SUBJECT PROJECT CONCEPT REPORT APPROVAL

Subject: Georgia Projects NH-IM-95-1(114) (130)
Camden County
Project Concept Report

PROJECT CONCEPT REPORT

**NH-IM-95-1(114)
NH-IM-95-1(130)
CAMDEN COUNTY**

ACCESS FROM WELCOME
STATION TO ST. MARY'S RD

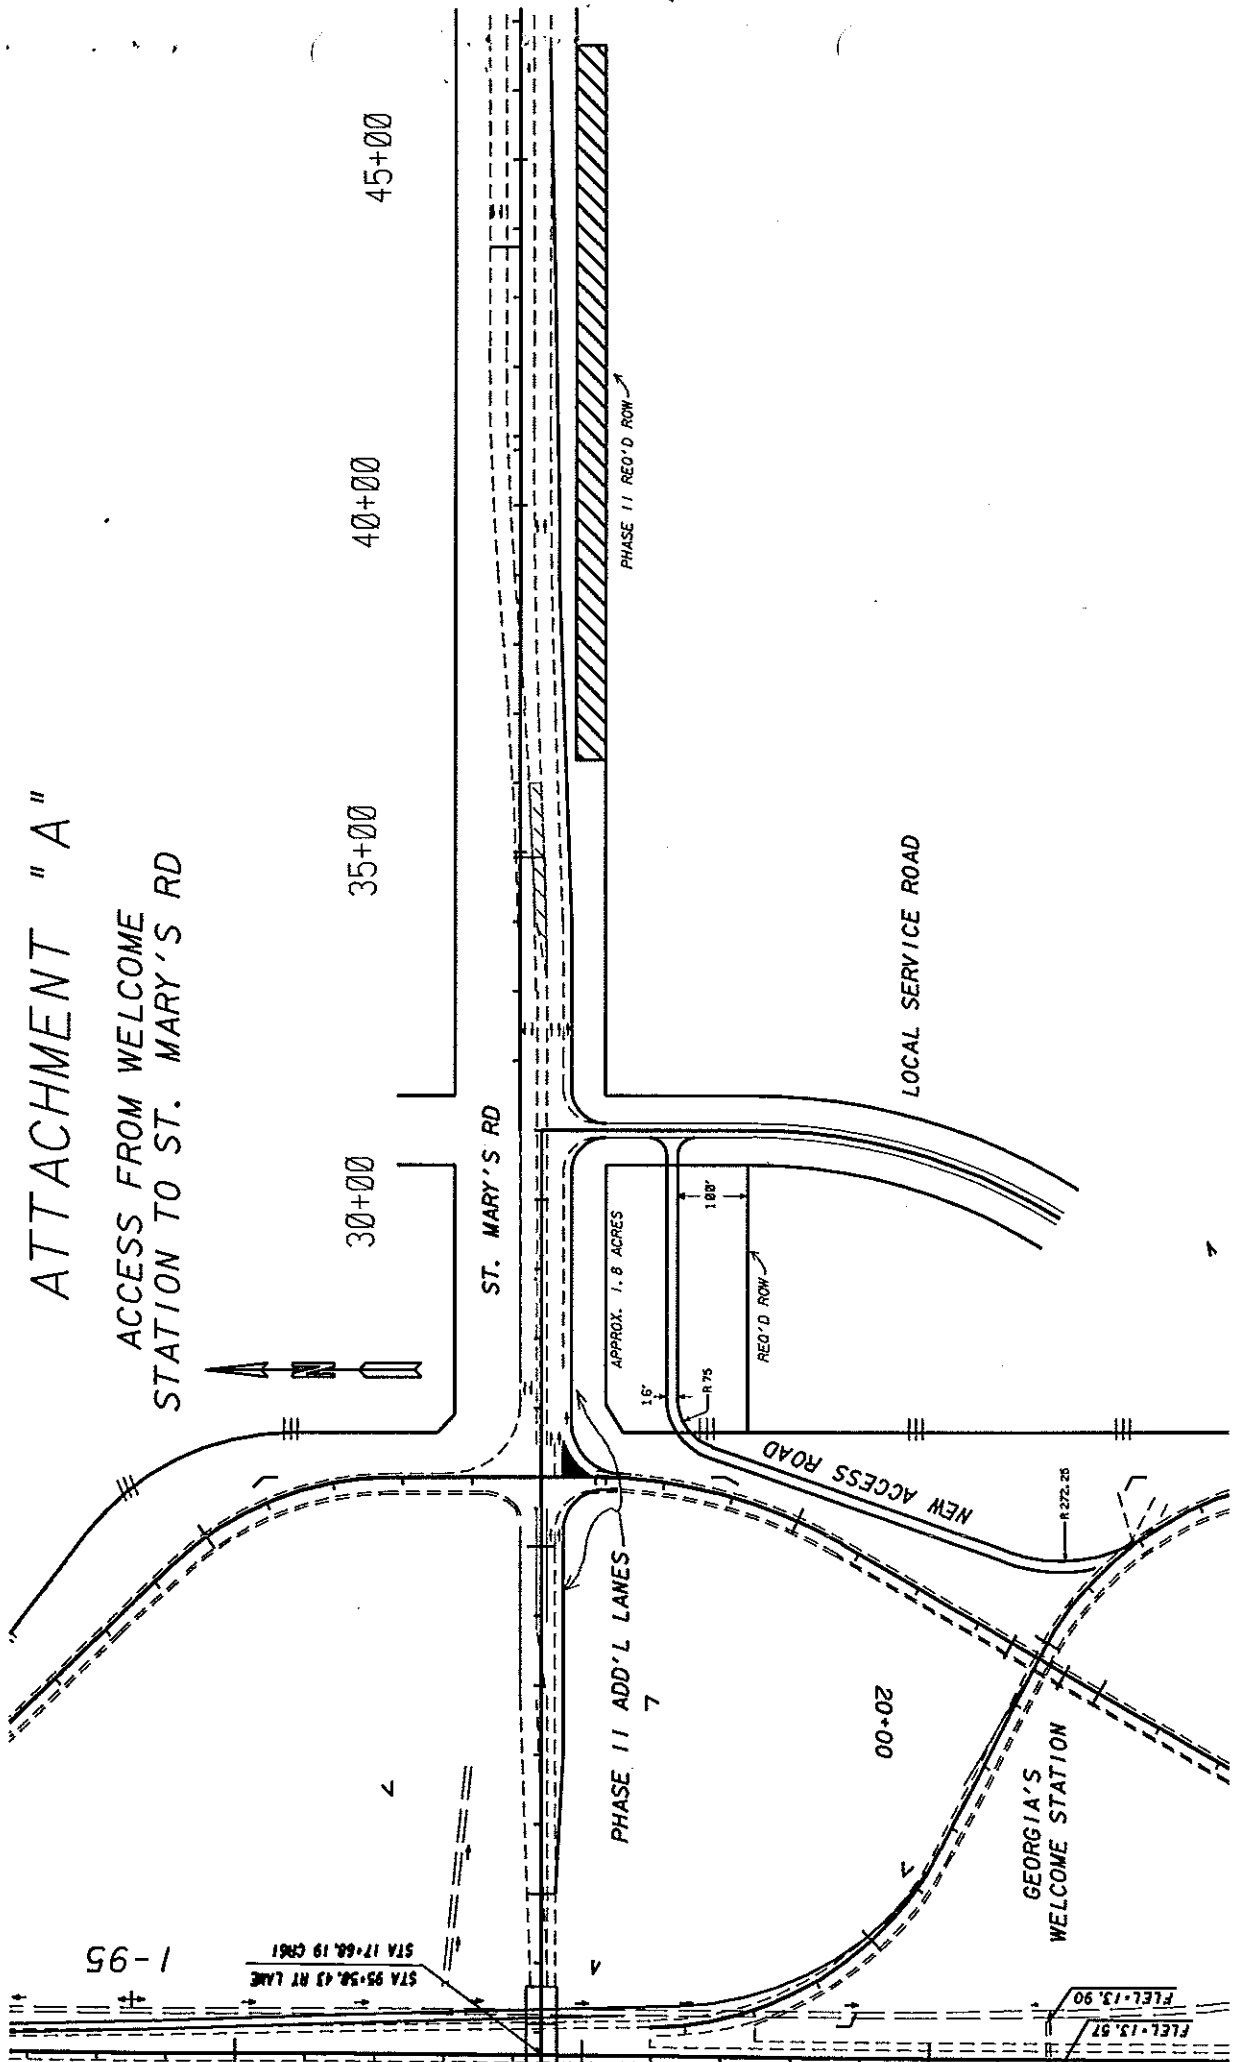
The report states that an access road will be constructed from
Georgia's Welcome Center to St. Mary's Road. It is our
understanding from previous discussions with your staff that the
access road will be constructed from the welcome center to an
existing local service road at a point just south of St. Mary's
Road. The report is otherwise acceptable and we are returning
the approved original for further processing.
